8982 A2

Service Manual

PHILIPS

- Correction to service manual

Fig. 1

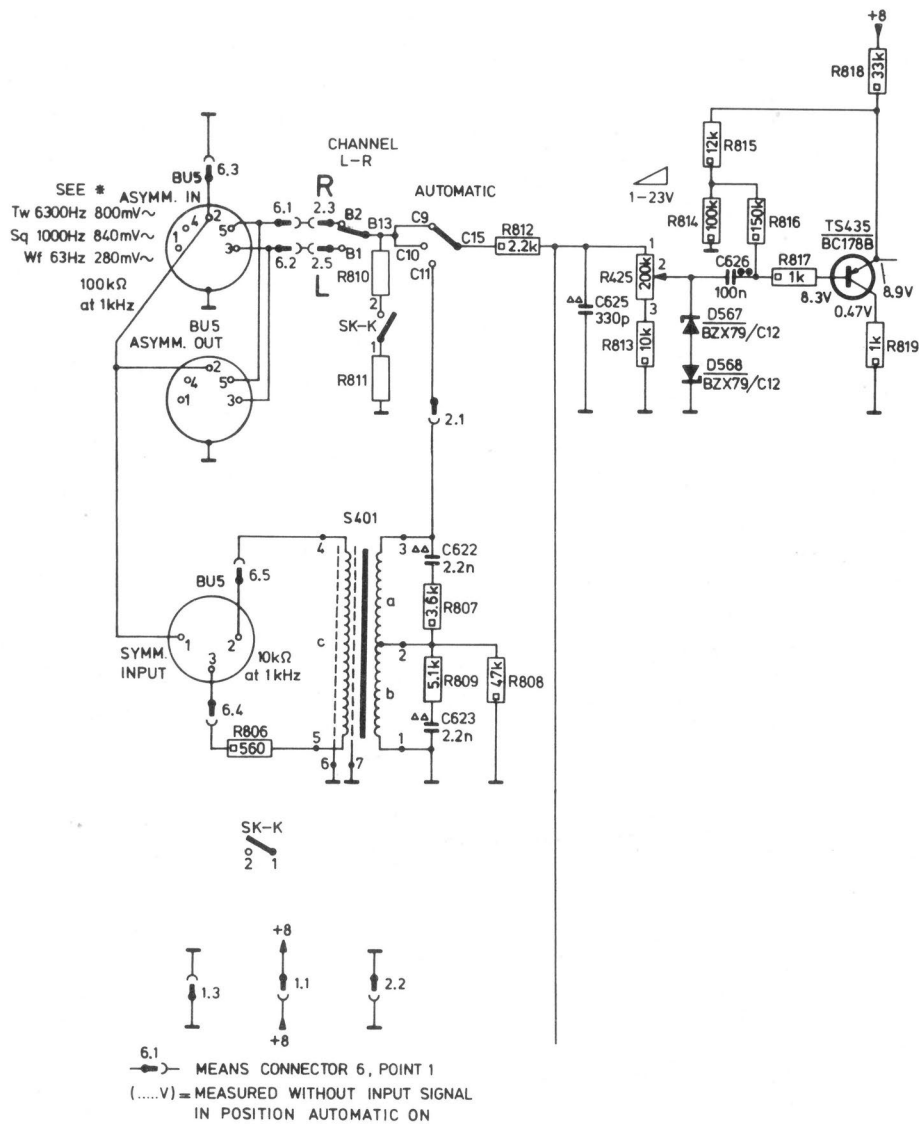
- To protect the bass speaker from DC-voltage (which may happen if one of the output transistors is short-circuited), a safety circuit has been added (from start production in /44R and also from PL05 in the other versions), located on a separate print (Figs. 3 and 5). As a result, also some other prints have been changed (Figs. 3 and 4). With this safety circuit is achieved that SK-Re40B cuts-off if a positive or negative DC-voltage appears at point A.

Moreover, a delay is built-in on the new print to suppress switch clicks of the amplifier.

The following components have been cancelled:

C687, D573, R944, TS481 and the cooling bracket of TS555.

The following components have been changed:

R1185 to $2,2 \text{ k}\Omega$ 1/8 W

R1180 to 180Ω 0,5 W

R1173 to $2,2 \text{ k}\Omega$ 1/8 W

R1170 to 39Ω 1/8 W

TS491 to BC107B (5322 130 40332)

C797 to $330 \mu\text{F}$ - 63 V

R943 to $22 \text{ k}\Omega$ 1/8 W

R963 to $4,3 \text{ k}\Omega$ 1/8 W

R970 to $2,2 \text{ k}\Omega$ 1,15 W

- To make switch-over of the input impedance possible, from start production in /44R and from PL06 in the other versions, switch SK-K (4822 278 90303), R810,811 (510Ω - 5322 116 54525) and disc A (4822 532 60643) have been added, see Figs. 1, 2, and 3).

Disc A is slid on the spindle of R425, so that this spindle had to be flattened over a greater length. The input impedance has now become:

$100 \text{ k}\Omega$ at 1 kHz with R425 in preamplifier position

$1 \text{ k}\Omega$ at 1 kHz with R425 in poweramplifier position
